CHARTER TOWNSHIP OF VAN BUREN PLANNING COMMISSION AGENDA Wednesday, May 11, 2022 – 5:30 PM Van Buren Township Hall 46425 Tyler Road

Subject: VBT-22-030 Ashley Crossroads North LLC/Rezoning Review; Application dated 1/5/22, revised

Subject: VBT 21-040-SPR, DTE Energy Substation/42061 Ecorse Road; Site Plan Review #2 -

DTE Morton Substation – 42061 Ecorse Road Preliminary Site Plan Review

Figure 2: Zoning of Subject Parcels and Surrounding Area General Area of Rezoning —————

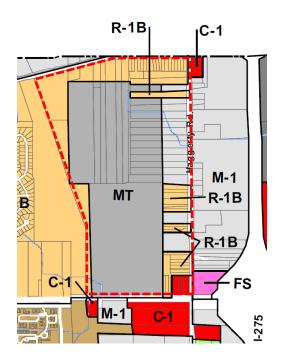
The table below summarizes the existing land use, zoning, and master plan designations in and around the subject site, according to the Master Plan and Zoning Ordinance. The map illustrates existing zoning of the surrounding area.

NFE JOB NO. SHEET NO. **C1A**

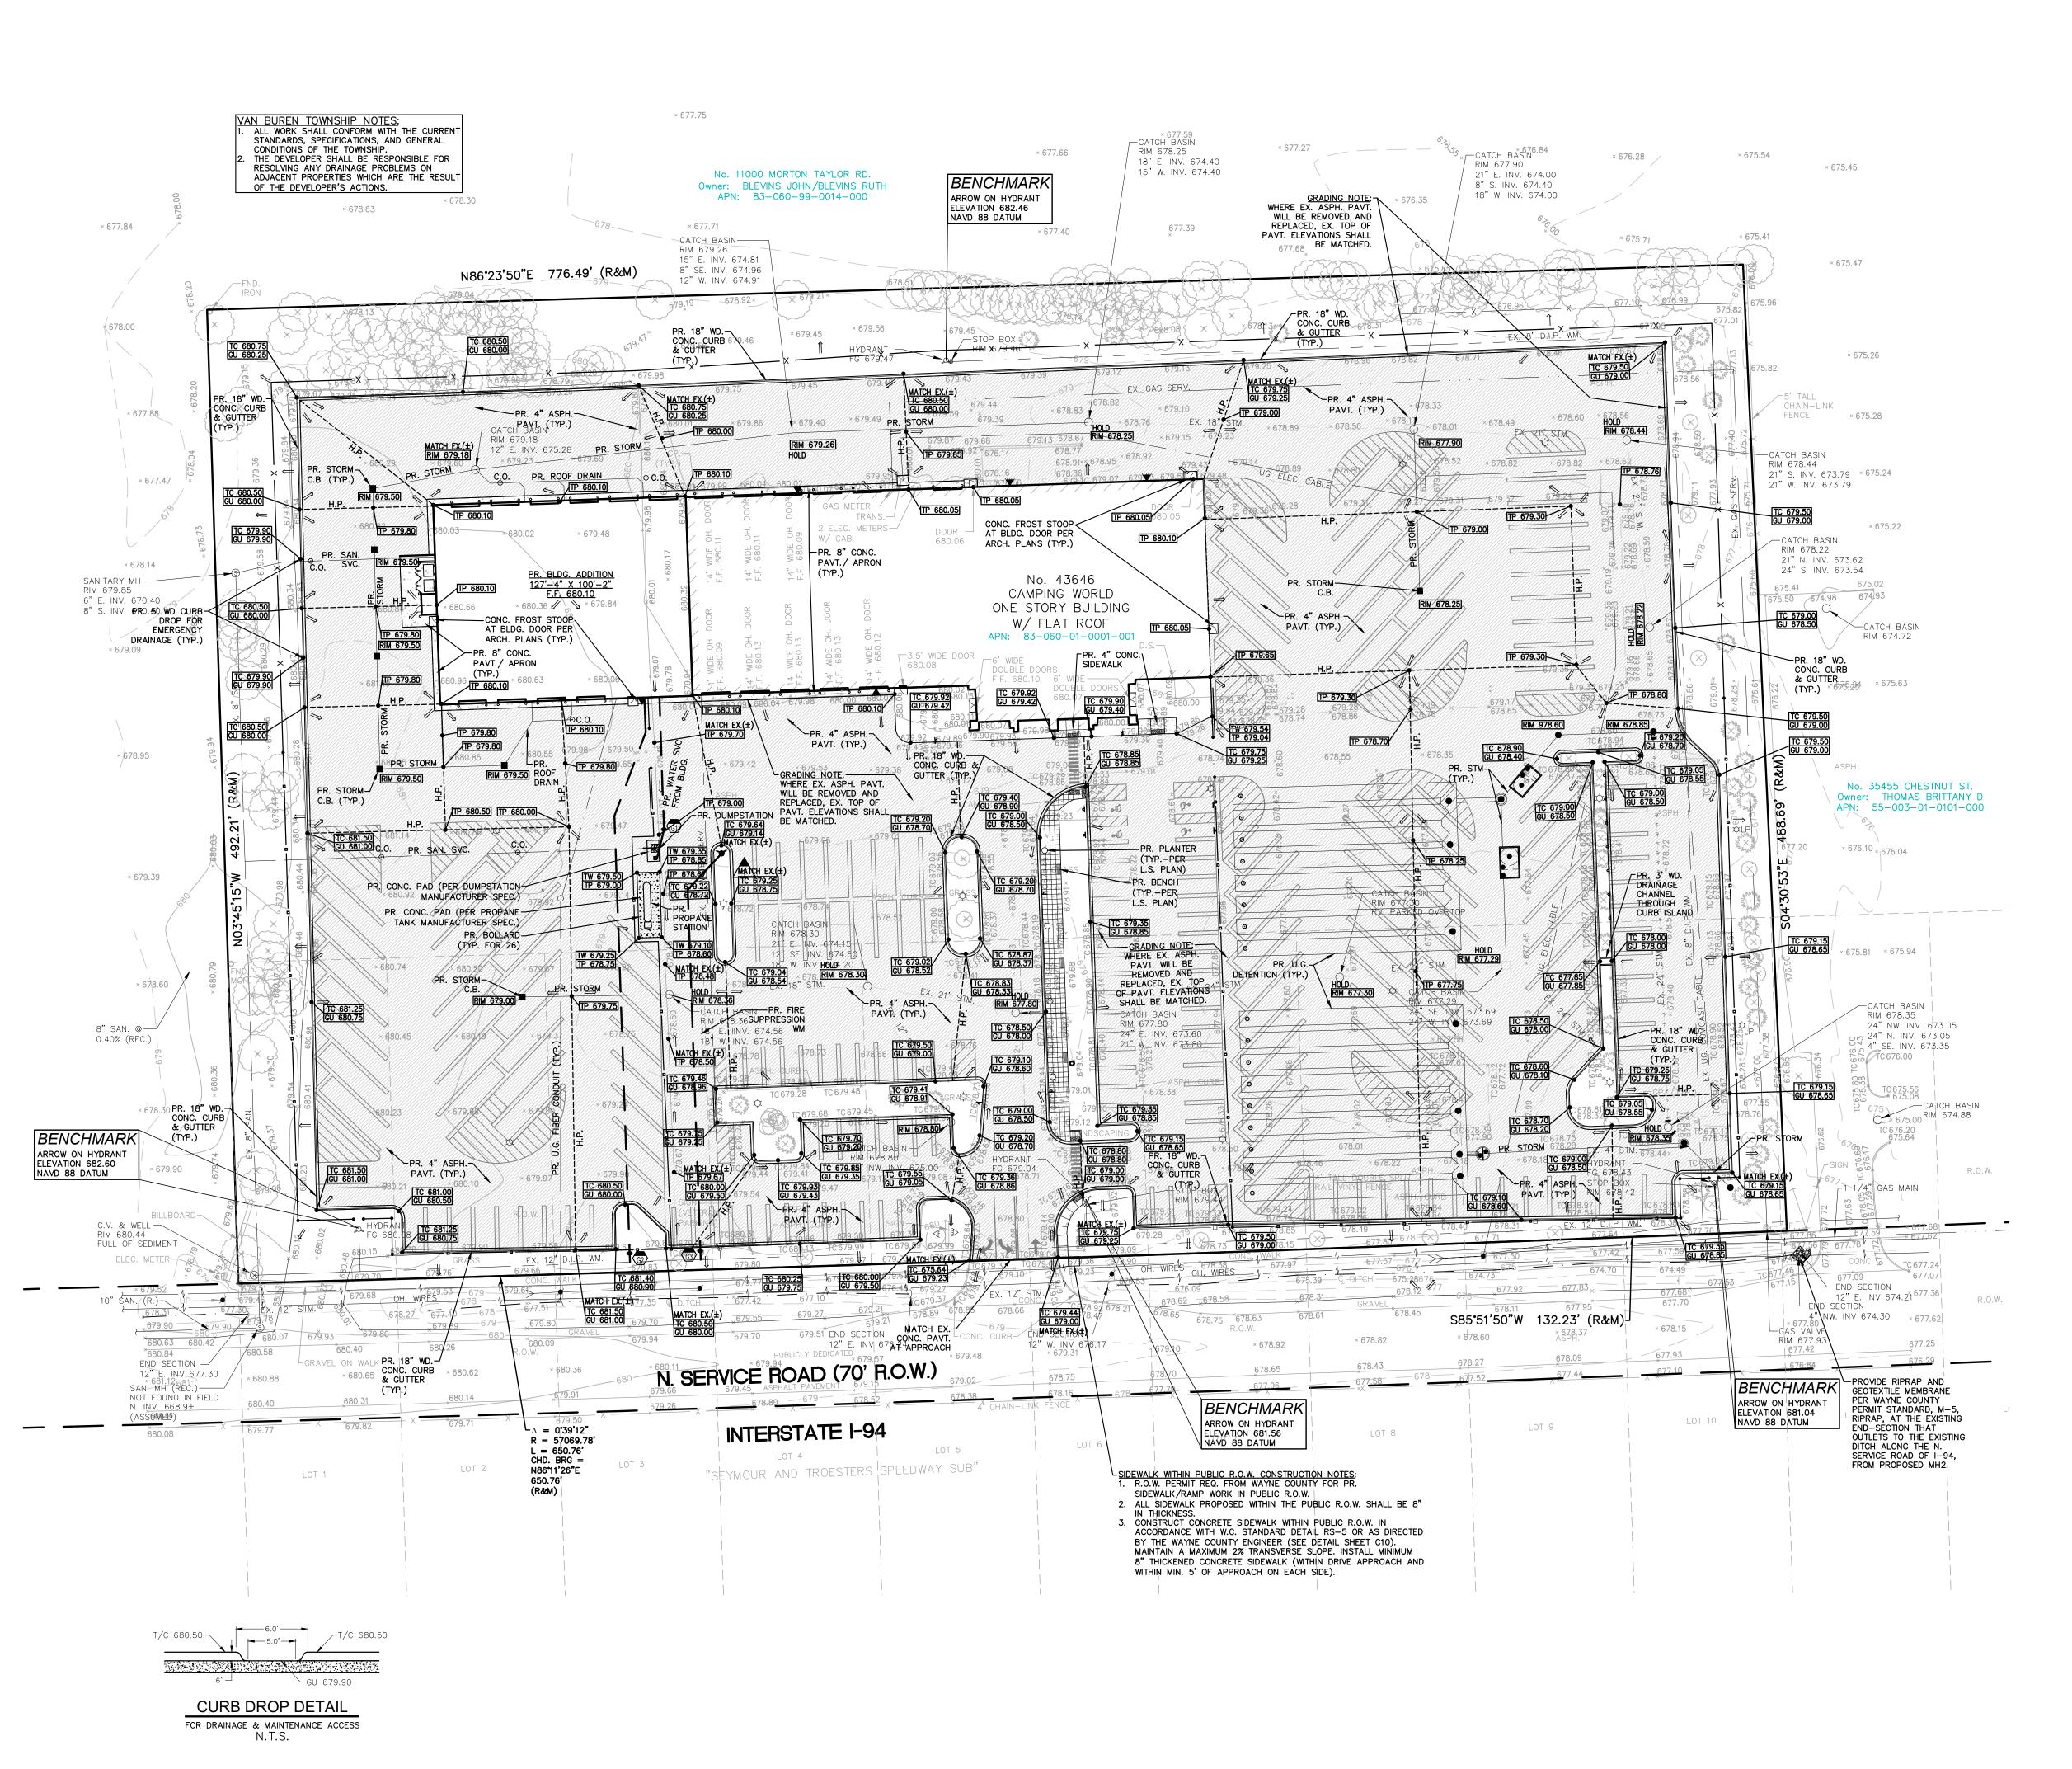
The turning radius into the east side gated area located on sheet C1A is not wide enough to accommodate the ladder truck. Corrected in 2/25/2022 plan set
